CITY OF CONCORD

Staff Report for Planning Board

Meeting on August 20, 2025 Project Summary – Major Subdivision

Project: 6-lot subdivision (2025-071)

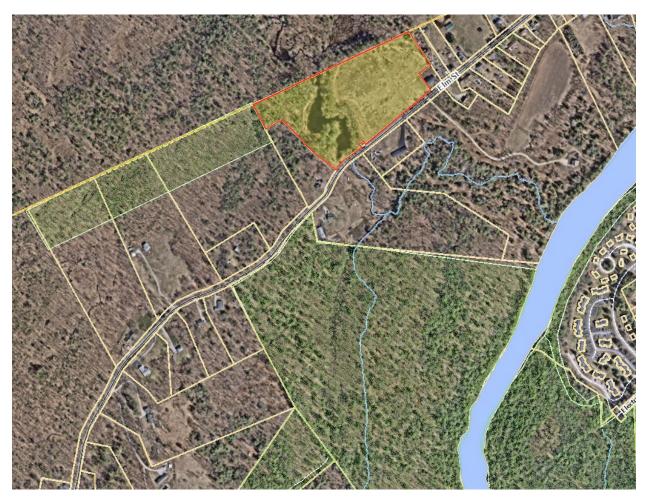
Recognizing the future development potential of Lot #1 (9.96 acres), and given that Elm Street is a collector roadway, and understanding that the applicant is proposing to construct a new cul-desac roadway to serve a portion of the development, it is important that the subdivision be designed to accommodate future extension of the new cul-de-sac to serve future development at Lot #1, thus negating the need for potential future driveway or roadway curb cuts on Elm Street. While the applicant has shown a 50-foot wide "public drainage and utility easement" from the proposed cul-de-sac to Lot #1, this is not a public highway easement.

The configuration of the proposed cul-de-sac roadway is not conducive to future extension to Lot #1. Specifically, the project as currently design, will cause future development at Lot #1 to be disconnected from the other 5 newly created lots at the development. This is inconsistent with the goals of the City's Master Plan, as well as the Subdivision Regulations and good planning practice regarding pedestrian and vehicular connectivity between developments, as well as subsequent phases of development which may occur at Lot #1 in the future. Additionally, rather than relying on the new cul-de-sac being constructed for the other 5 lots for access, future development at Lot #1 would require additional curb cuts on Elm Street. This is also inconsistent with goals of the City's Master Plan, as well as the Subdivision Regulations and good planning practice for access management on collector roadways. Staff notes that the Planning Board, in accordance with Section 20.21 has the authority to require that rights-of-way for the future layout or extension of streets be shown on the plat and easements be recorded for the future streets. In accordance with Section 20.23, the Board also has the authority to require the applicant to design and construct the proposed cul-de-sac roadway so that it will serve Lot #1. Therefore, in accordance with these provisions, the Board has authority to require the applicant to revise its proposed design to address these concerns.

- 9.2 Based on the findings of fact, staff recommends that the Planning Board continue the public hearing to a date certain of October 15, 2025, so that the applicant, in accordance with Section 20.21 Procedure for Subdivisions Where Further Subdivision Is Possible, may revise the application to accommodate additional right-of-way and design configuration for future layout of a subdivided lot 1 and extension of the new public street. The redesigned new public street would be considered as a temporary dead end until said future subdividing of lot 1 takes place, so Section 20.23 Temporary Dead-End Streets shall also be considered. The design shall mitigate the need for unnecessary driveways or roadway curb cuts on Elm Street to allow for future development, and bring the application into conformance with the intent of the master plan, subdivision regulations, and good planning practices regarding neighborhood connectivity and management of curb cuts on collector roadways. The applicant shall submit the revised application by Wednesday, September 17, 2025, at 4:00 p.m. to allow staff time to review the revised application and prepare a staff report for the Board's consideration accordingly. In addition to addressing these design issues, the continuance would also grant the Central New Hampshire Regional Planning Commission time to respond to the Development of Regional Impact notice for this application, as well as provide the applicant to consider potential conservation easement at Hardy Brook.
